Docket Number:	14-AAER-02
Project Title:	Computer, Computer Monitors, and Electronic Displays
TN #:	204156
Document Title:	ITI/Technet Computer Presentations
Description:	PCs - Methodology/Framework, Staff Workshop: Computers, Computer Monitors and Signage Displays - Shahid Sheikh Intel Corporation, April 15, 2015
Filer:	System
Organization:	CEC/Harinder Singh
Submitter Role:	Commission Staff
Submission Date:	4/13/2015 4:07:06 PM
Docketed Date:	4/13/2015

California Energy Commission
Staff Workshop: Computers, Computer Monitors,
and Signage Displays

PCs – Methodology/Framework

Shahid Sheikh

CEC Targets – AIO impact

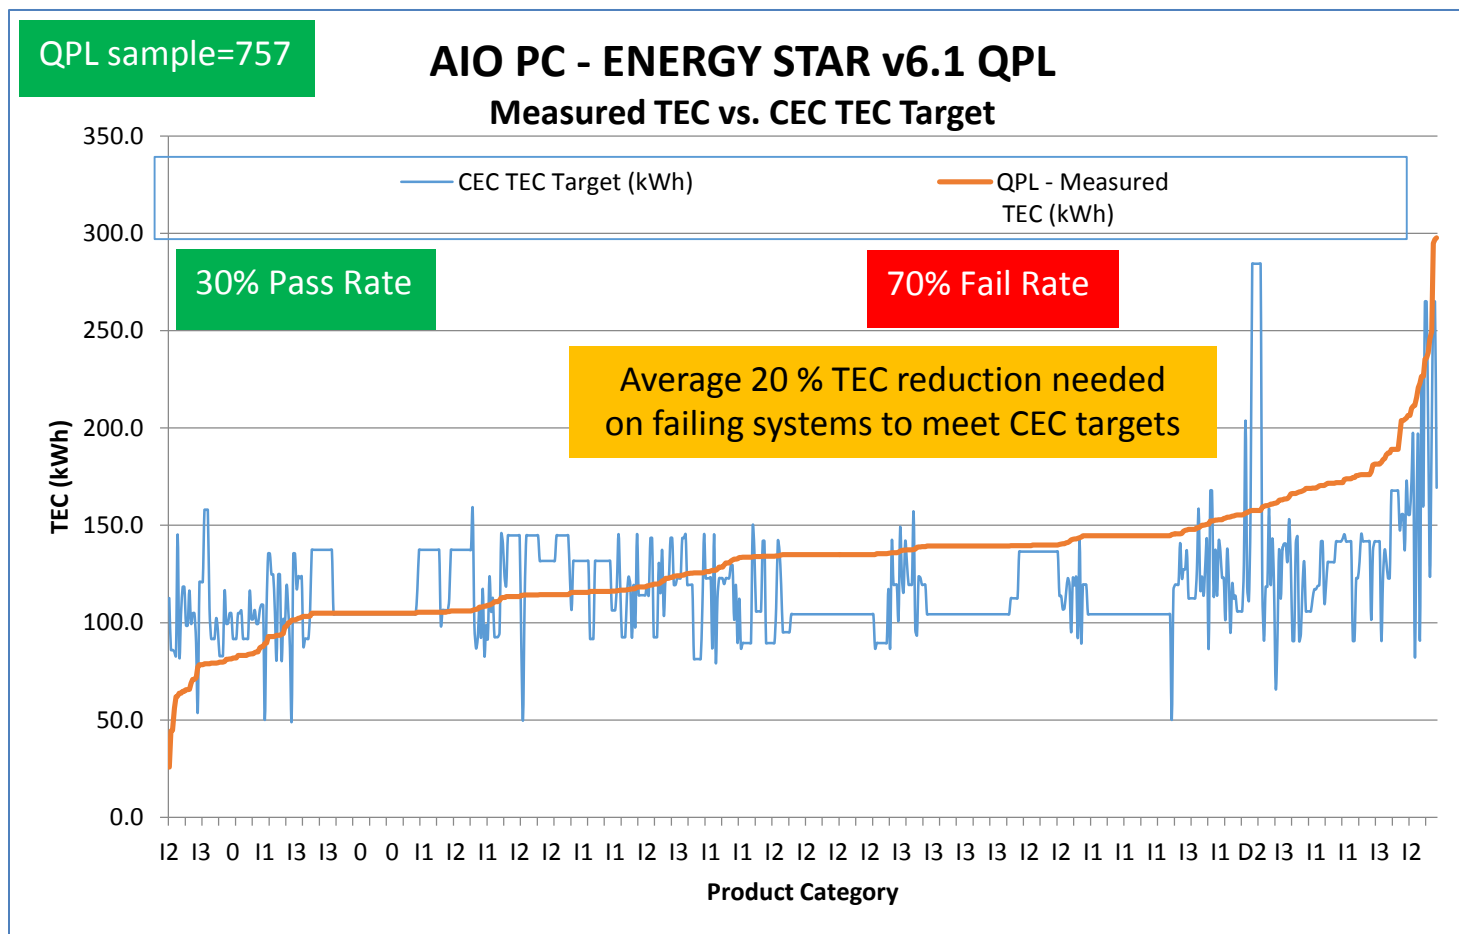
- **AIO PC product impact:**
 - High failure rate. Expect even higher % failure on all shipping systems
 - ~20% TEC reduction by 2018 on Energy Star systems, to comply with proposed targets (Need access to CEC data to validate cost effectiveness assumptions)

CEC Targets – NB Impact

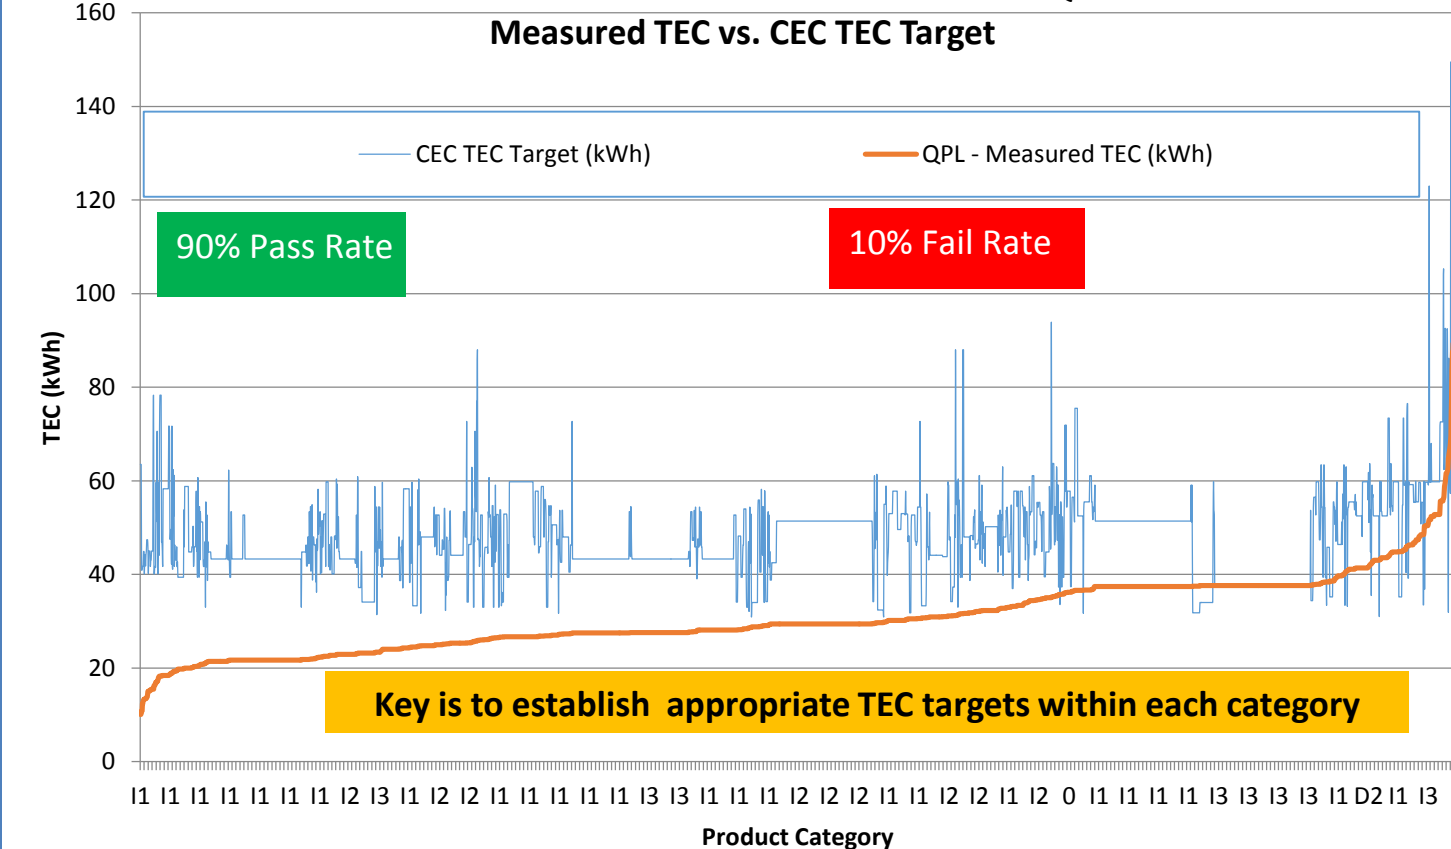
- **NB PC product impact:**
 - **Moderate failure rate (mainly High-end systems at risk). Expect higher % failure on all shipping systems. A good example of why one-size-fits-all approach is not appropriate**
 - **Need access to CEC data to validate assumption.**
